Revise:  
El Paso County  
Planning and Community Development Department  
2880 International Circle, Suite 110  
Colorado Springs, CO 80910  
PCD File No. PPR-21-026

RE: Drainage Conformance Letter  
Falcon Marketplace, Lot 9  
Falcon, CO 80831.

PROJECT: Slim Chicken's - Falcon  
 PROJECT NO. 21-030  
 DESIGN BY: GJB  
 DATE: 6/10/2021

Figure 6-5. Colorado Springs Rainfall Intensity Duration Frequency

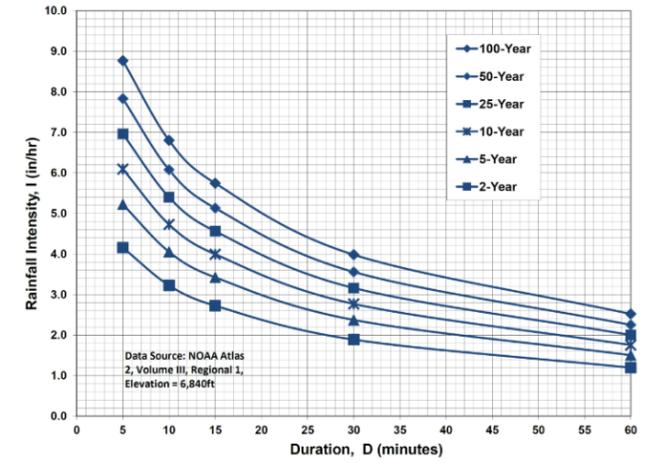
Update intensity per Figure 6-5
